**DEL TACO**  
FRESH FLEX DRIVE - THRU

DEL TACO STORE  
ENLARGED SITE PLAN  
1500 GIBSON BLVD  
ALBUQUERQUE, NM  
PROJECT #2107

SHEET NUMBER  
AS-1.1

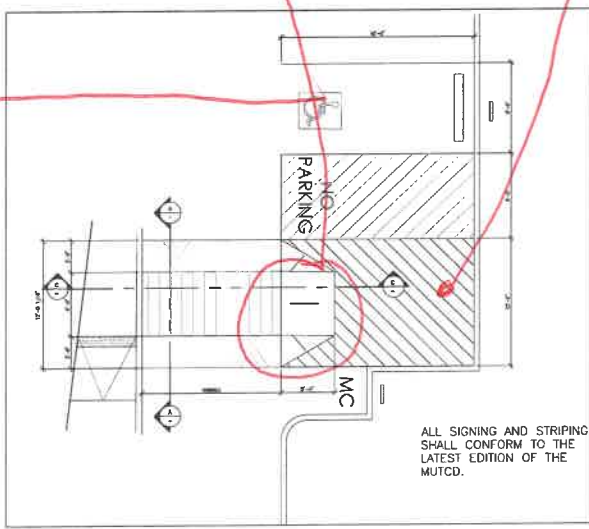
MISSING  
Sht. 2.0  
(details)

Provide detail & Sht 2.0

provide  
striping detail?

Make sure  
ramp design stays on Private property

Any problems  
w/ ramp vs 6' pathing? tripping hazard? Y or N?
